ADDENDUM NO. 3

DATE: July 31, 2013

Contract 13-C-00020; Osborne Pumping Station Rehabilitation

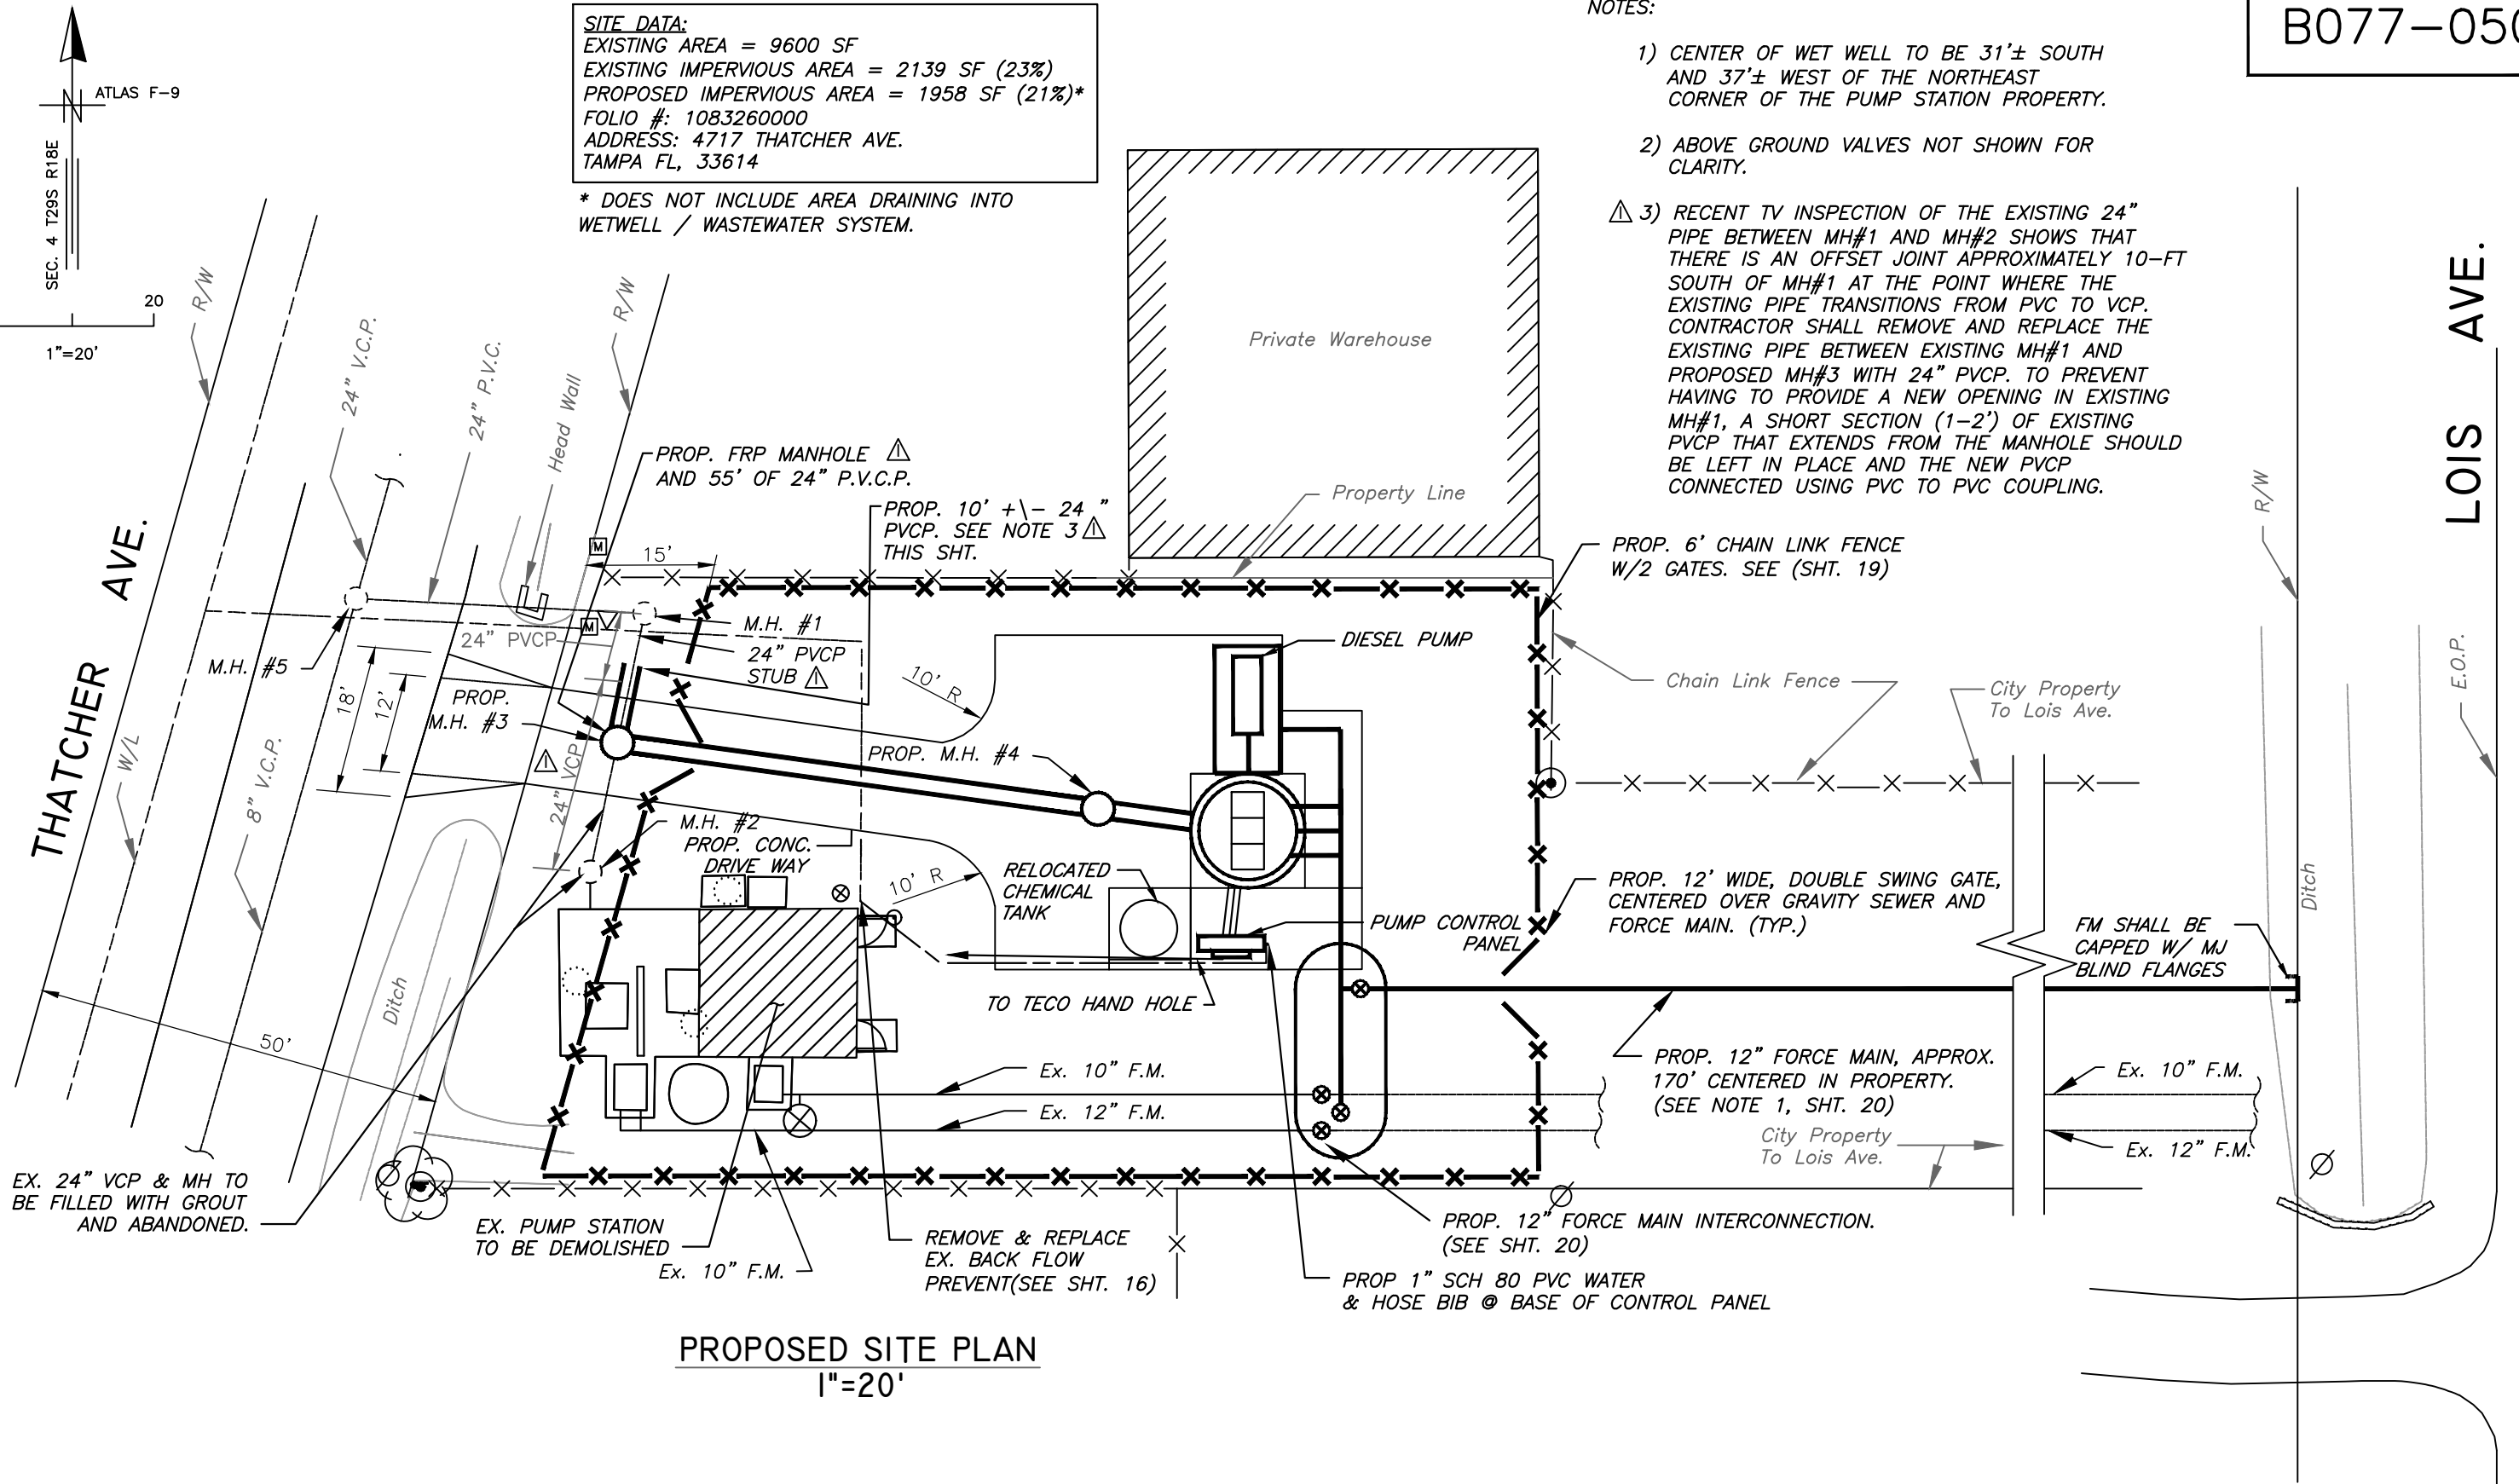
Item 2: Asbestos Survey Requirement Clarification: See attached revised Sheet No. 3, General Notes, Note G-34.

Item 3: Concrete Pavement and Subbase Clarification: See attached revised Sheet No. 3, General Notes, Note G-23.

Item 4: Proposed Construction Sequence Plan: See added notes on Sheet No. 3, General Notes, P-1 through P-10.

- △ G-23. ALL CONCRETE PAVEMENT, UNLESS OTHERWISE NOTED, SHALL BE MIN 6" THICK CONCRETE WITH 4X4 W2.1XW2.1 WWF. CONCRETE SHALL BE CONSTRUCTED ON COMPACTED SUBBASE (MINIMUM 98% MODIFIED PROCTOR) WITH 1.5" DEEP CONTROL JOINTS SAWCUT @ 15' MAX, CUT WITHIN 12 HRS OF CONCRETE PLACEMENT.

- △ G-34. THE CITY DOES NOT BELIEVE ASBESTOS IS PRESENT IN THE BUILDING. PER EPC REQUIREMENTS, CONTRACTOR WILL BE REQUIRED TO PROCURE A THIRD PARTY ASBESTOS SURVEY FROM A LICENSED ASBESTOS CONSULTANT. DEMOLITION OF PUMP STATION BUILDING CANNOT BEGIN UNTIL (3) WEEKS AFTER THE ASBESTOS SURVEY IS SUBMITTED TO THE ENGINEER. THE CITY WILL FURNISH EPC WITH THE REQUIRED NOTIFICATION. IF THE SURVEY DISCOVERS THE PRESENCE OF ASBESTOS, THE CITY WILL UTILIZE CONTINGENCY FUNDS FOR THE ASBESTOS REMOVAL IN ACCORDANCE WITH EPC STANDARDS.

△ PROPOSED CONSTRUCTION SEQUENCE PLAN

OSBORNE AVE. PUMP STATION
PROFILE VIEW

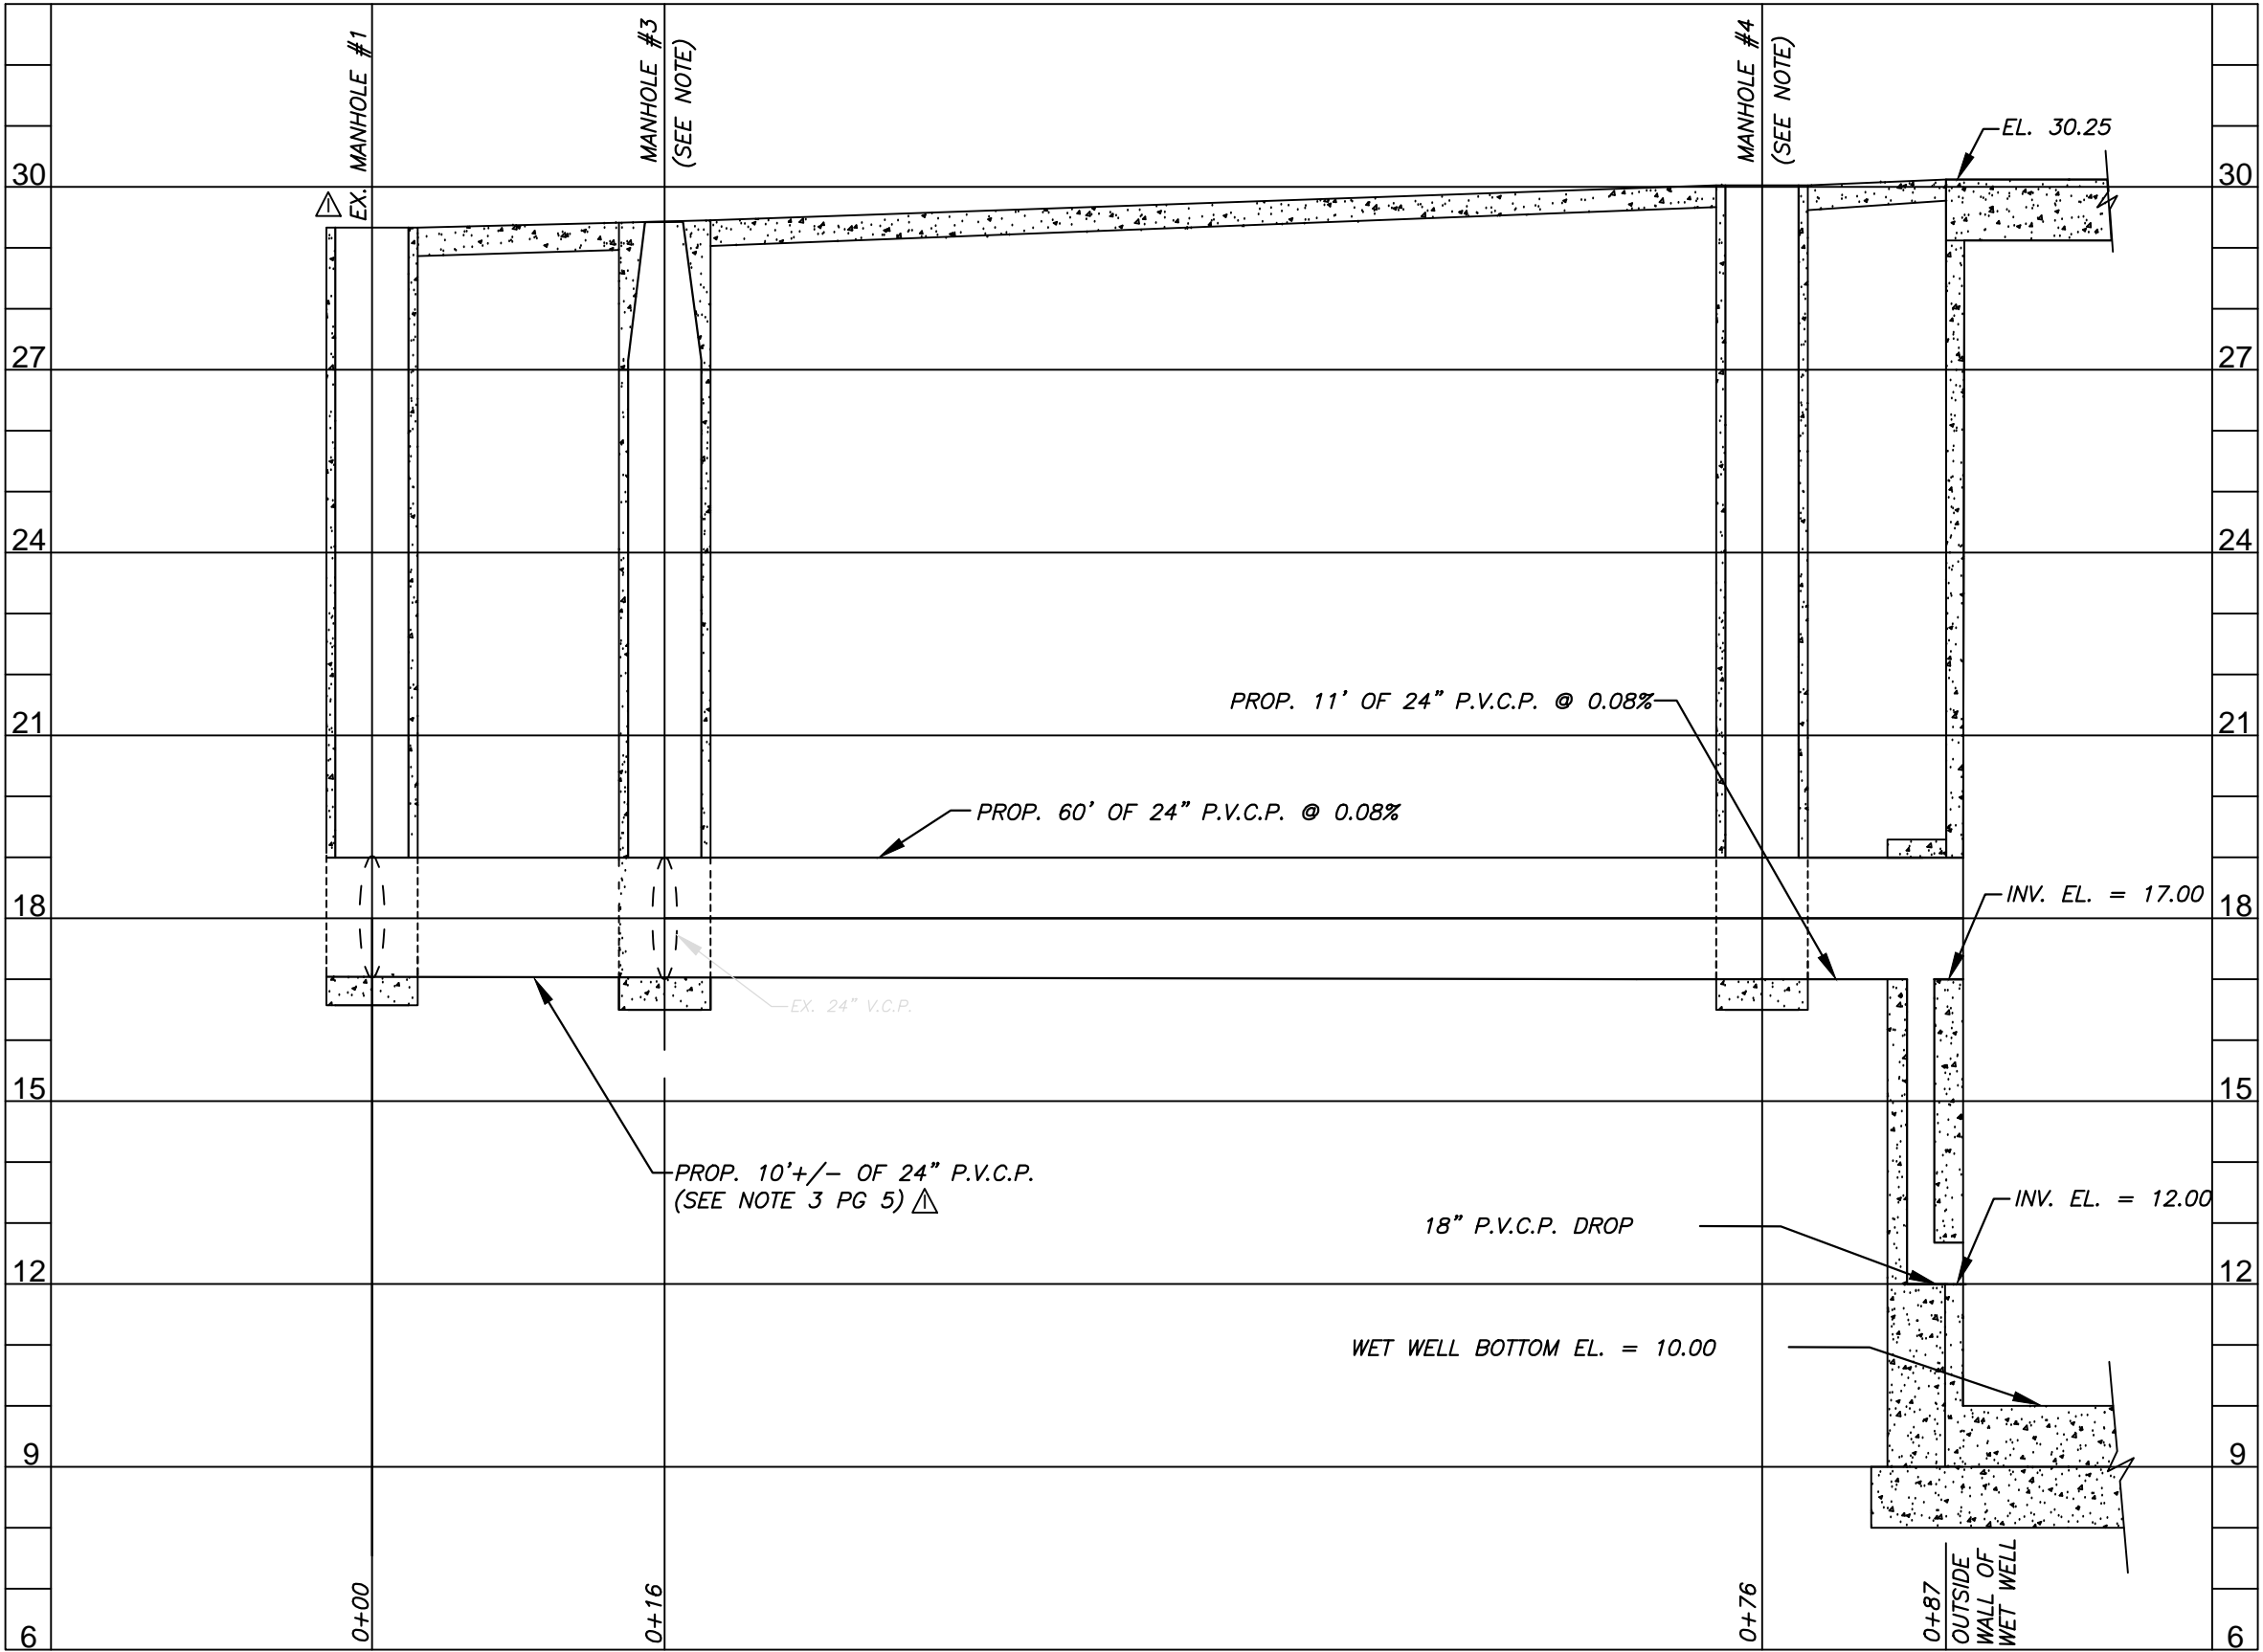
No.	DATE	REVISIONS
3		
2		
1	7/26/13	ADDED CONSTRUCTION SEQUENCE, CHANGED MH#3, ADDED NOTE 3 SHT 5, REVISED PROFILE

STA. 0+16
PROP. MANHOLE CENTERED BETWEEN M.H. #1 AND M.H. #2.
TOP EL. = 29.30 +/-
INV. EL. = 17.08(E)
INV. EL. = 17.41(S)
INV. EL. 17.16± (N) CALCULATED.
PLUG 24" V.C.P. (SOUTH) WITH BRICK AND MORTAR AND RECONSTRUCT FLOW CHANNEL AFTER ACCEPTANCE OF NEW PUMP STATION.
